# **AQUIND INTERCONNECTOR**

Statement of Common Ground Between  
AQUIND Limited and Highways England  
FINAL

Document Ref: 7.5.10  
PINS Ref.: EN020022

**DATE: 25 FEBRUARY 2021**

TITLE  
GEOMETRIC MEASUREMENTS FOR  
A3(M) JUNCTION 2 MODELLING

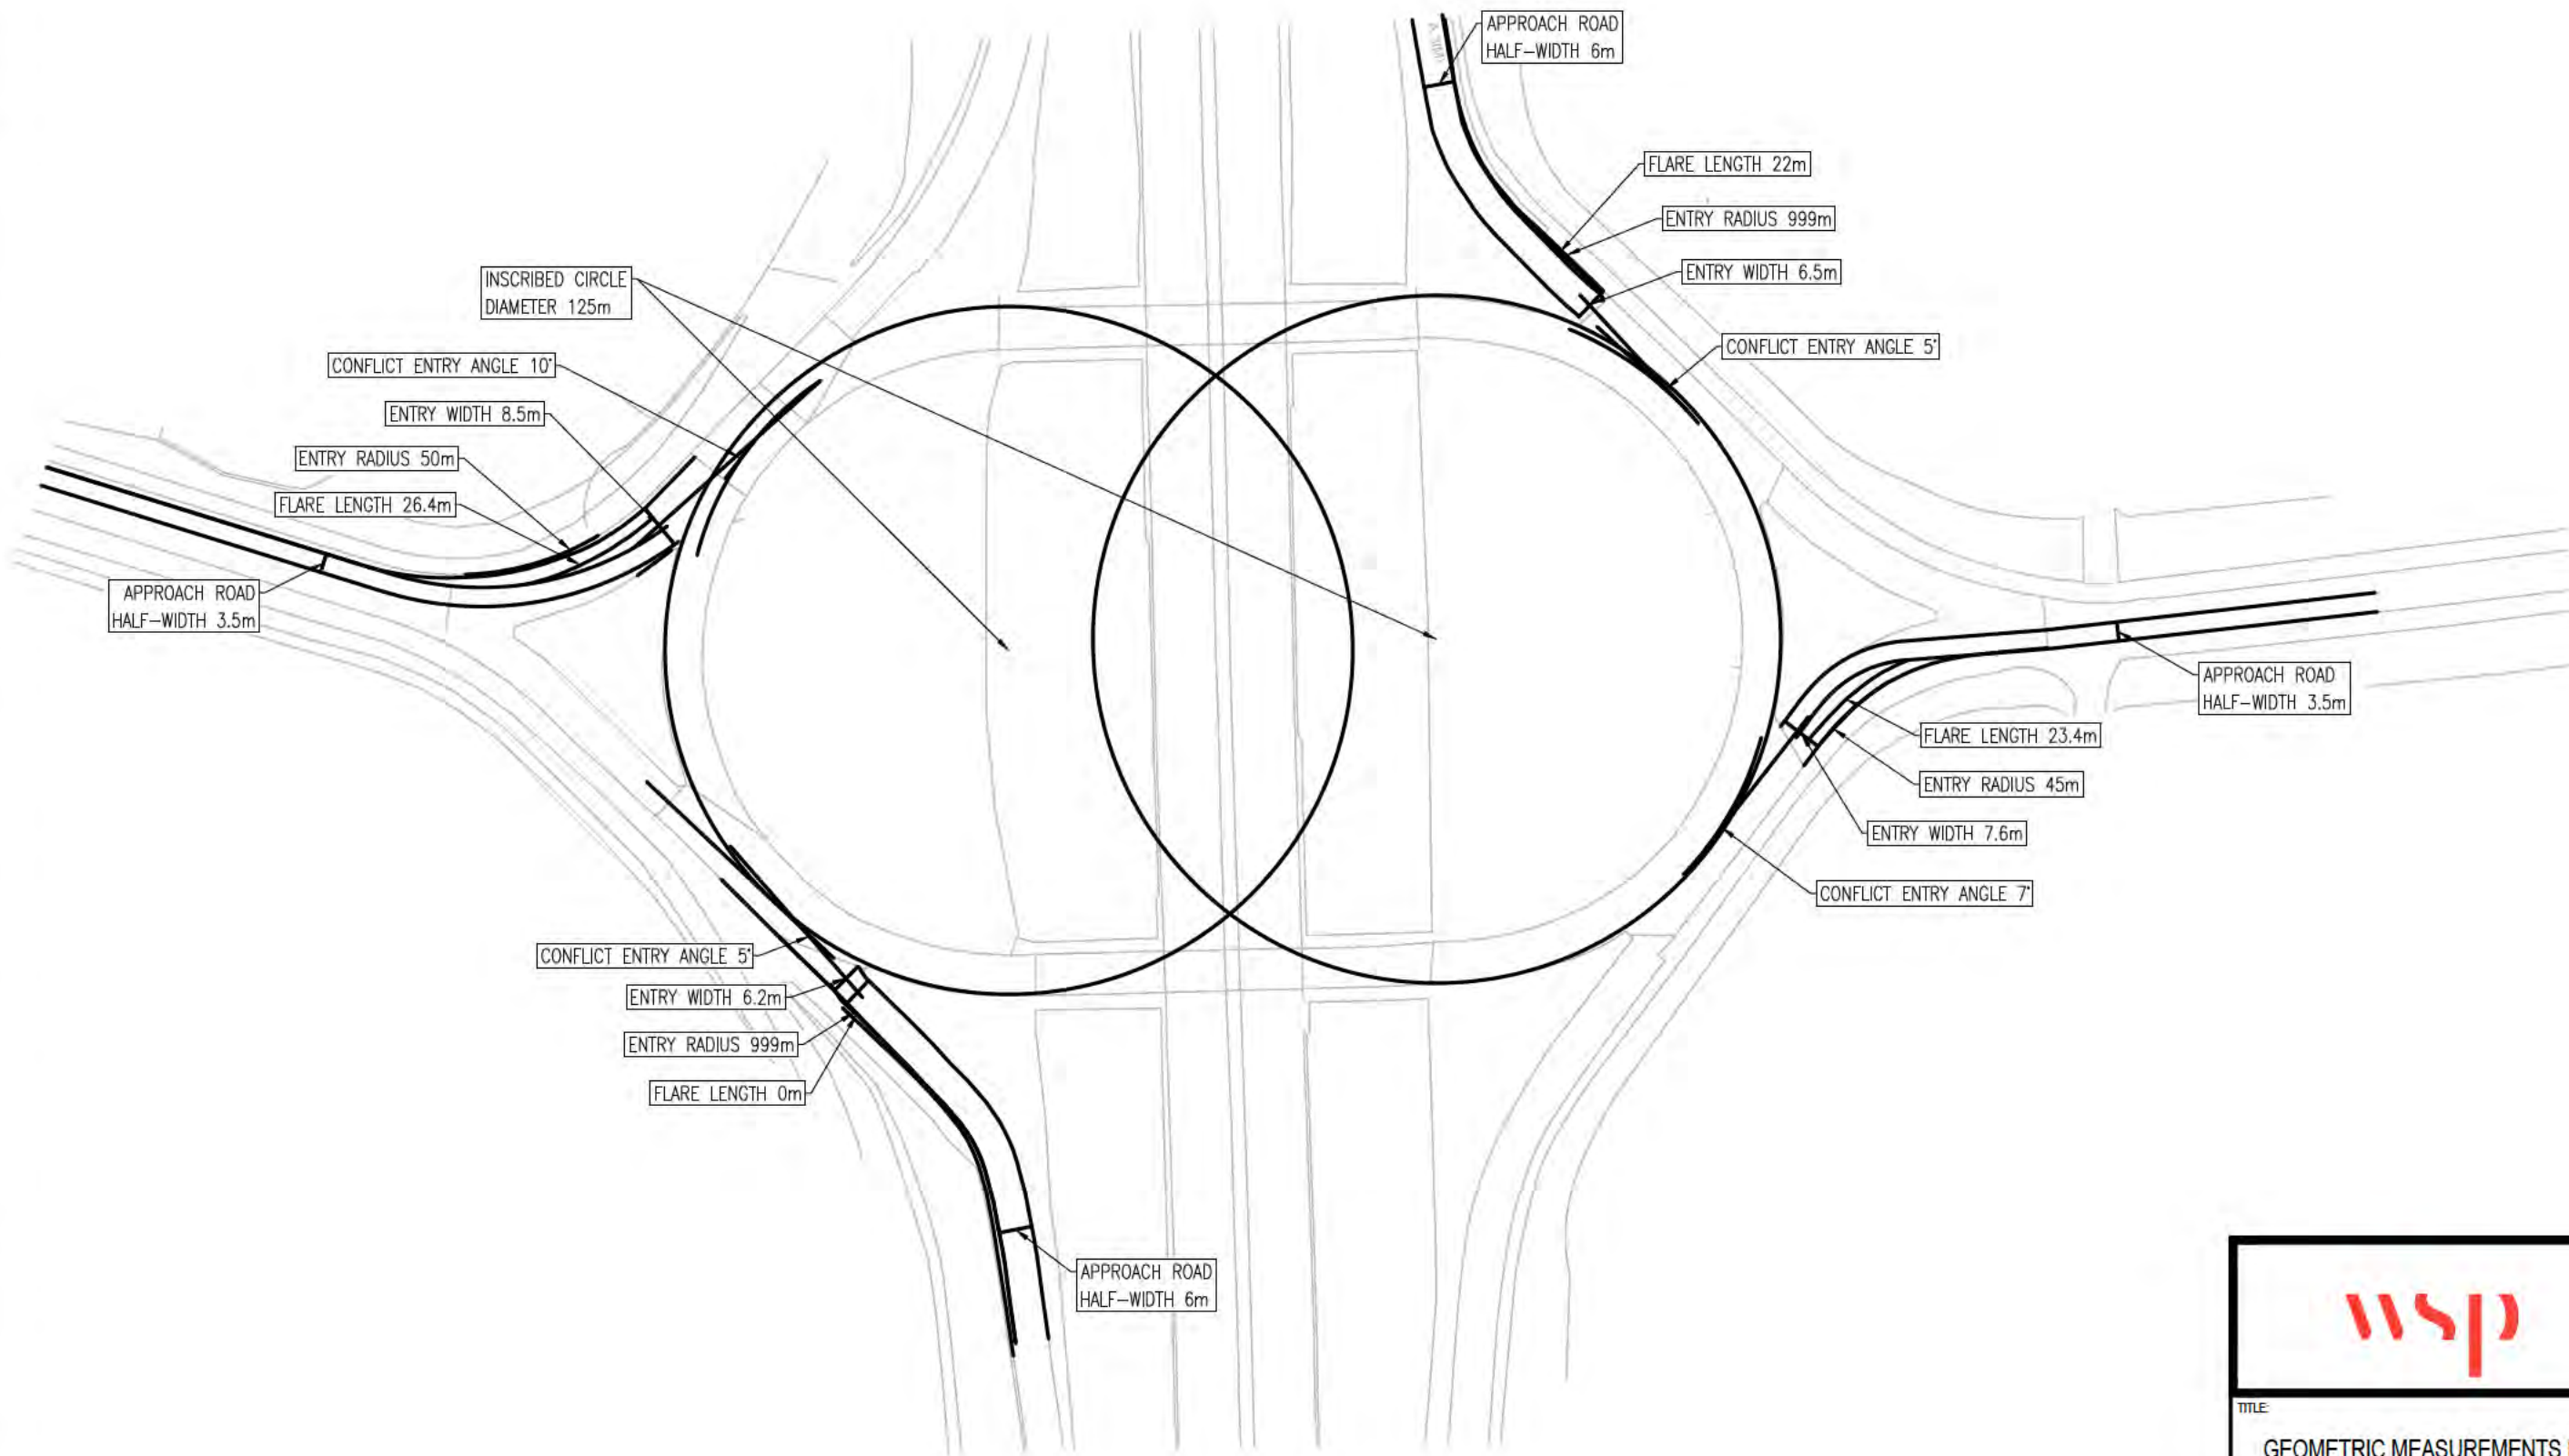
8. With regard to A3(M) Junction 2, the flow diagrams or the models should be corrected to ensure that these are consistent, and that clarification is provided. Furthermore, there appears to be no flows from A3(M) south to Dell Piece East and confirmation should be provided that this is correct (para 3.2).
9. With regard to A3(M) Junction 2, the AM peak ARCADY analysis for this junction should be provided (para 3.3).
10. With regard to A3(M) Junction 3, there appears to be no flows from A3(M) south to Hulbert Road East, and confirmation should be provided that this is correct (para 3.9).
